Quality Bulletin

Service Action SP1082: Stabilizer Bar Link Model Year 2026 Polestar 4

SP1082

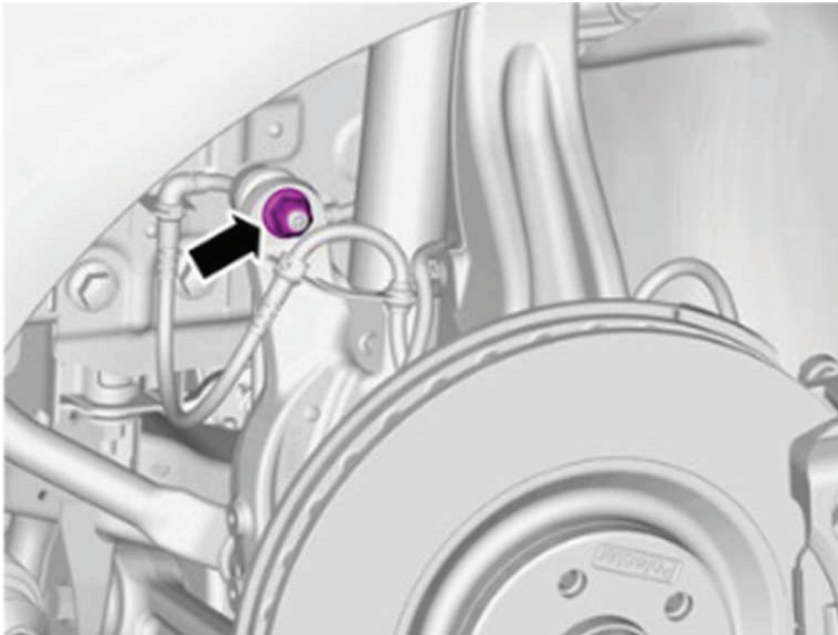
The concern with the stabilizer is low torque on the nuts for the stabilizer bar link. This may cause noise from the front suspension.

Perform Actions to both sides of the vehicle. Applicable to front sway bar only

Perform all steps to both left and right, upper and lower end links

Loosen the nut to reset torque

Important: Make sure the ball joint does not rotate

1. Safely lift vehicle per VIDA (Information / General Safety Information / 8 Body & Interior / 81 Body frame / 810 general / Working with a car lift)
2. Remove the front wheels per VIDA (Information / Removal, replacement and installation / 7 Springs and wheels / 77 Wheels, tyres / 770 complete wheels / Wheels)
3. Loosen or remove upper and lower sway bar end link nuts, highlighted in images below
4. Reuse the existing nut, torque both nuts to 70Nm (52ft-lbs) then tighten additional 45 degrees
5. Repeat for other side of vehicle
6. Lower and perform a short test drive

Torque: 70Nm (52ft-lbs) + 45 degrees
